April 3, 2019

Re: Addendum to Source Control Evaluation Work Plan to Assess Data Gaps for Completion of RI/FS for Former E.A. Nord Facility, Everett, Washington (FS ID 2757)

Report **WORK PLAN ADDENDUM**

Drawing **PROPOSED SAMPLING LOCATIONS AND LABORATORY ANALYSES**

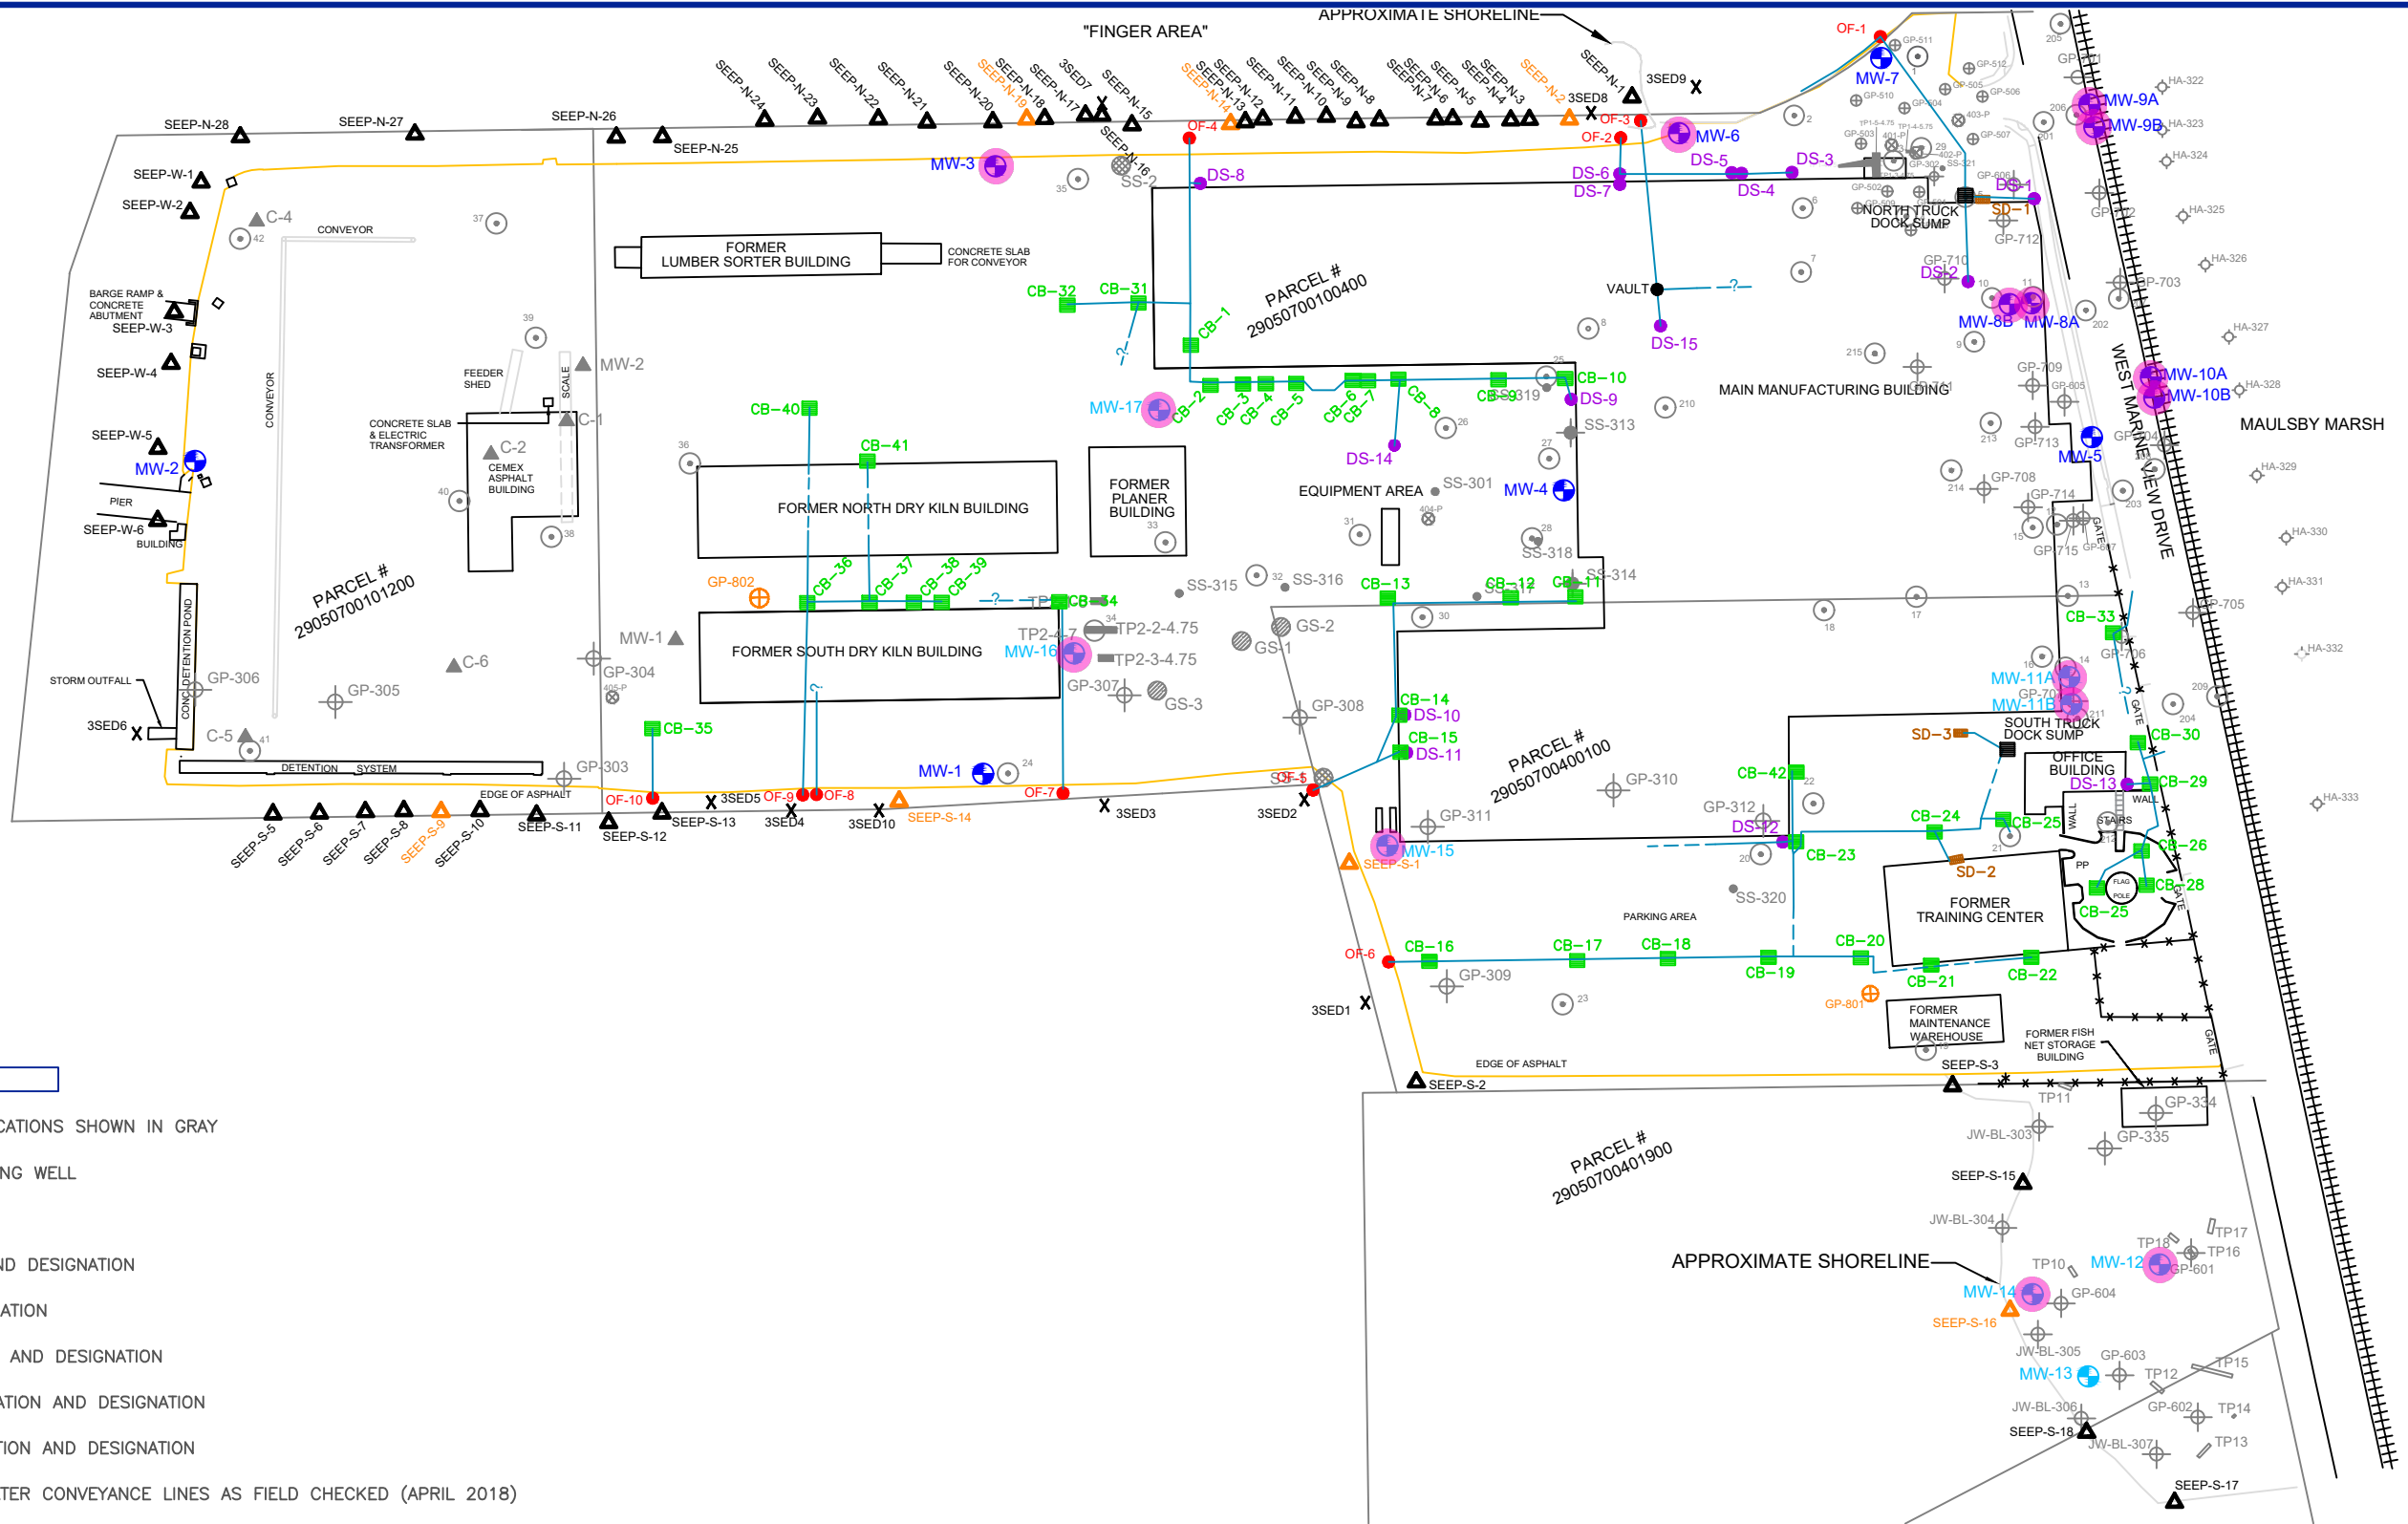
The scope of work presented in this Work Plan Addendum was based on communications and discussions with Washington Department of Ecology (Ecology) following submittal of the January 2019 SCE Summary Report and upon Ecology's review of the October 2016 Final Draft RI/FS. The proposed sampling locations are presented on **Figure 1** and sampling rationale and proposed analytical suite for each sample location is included on **Table 1** and is described below.

Proposed Additional Assessment: One soil boring will be completed for collection of soil samples and a deep permanent groundwater monitoring well (MW-11B) will be installed for collection of

a groundwater sample. A nested shallow well will be installed adjacent to this deep well as MW-11A (similar design to existing wells MW-8A/8B, MW-9A/9B, and MW10A/10B) for collection of a groundwater sample.

Proposed Additional Assessment: Three soil borings will be completed for collection of soil samples and three permanent groundwater monitoring wells (MW-12 to MW-14) will be installed for collection of groundwater samples. MW-12 will be located adjacent to former boring GP-601 and former test pit TP-16, MW-13 will be located adjacent to former boring GP-603, and MW-14 will be located adjacent to seep sample location S-16.

Proposed Additional Assessment: Two soil borings will be completed for collection of soil samples and two permanent groundwater monitoring wells (MW-15 and MW-16) will be installed for collection of groundwater samples. MW-15 will be located outside of the existing building in-between former boring GP-311 and seep sample S-1, and MW-16 will be located adjacent to former boring GP-34 and former test pit TP-2.

Proposed Additional Assessment: Two soil borings will be completed for collection of soil samples and grab groundwater samples from a temporary well (GP-801 and GP-802) and one soil boring will be completed for collection of soil samples and one permanent groundwater monitoring well (MW-17) will be installed for collection of a groundwater sample. GP-801 will be located adjacent to the former maintenance warehouse, GP-802 will be located between the former north and south dry kiln buildings, and MW-17 will be located in a former operation and maintenance area and adjacent to damaged stormwater lines near the center of the Site.
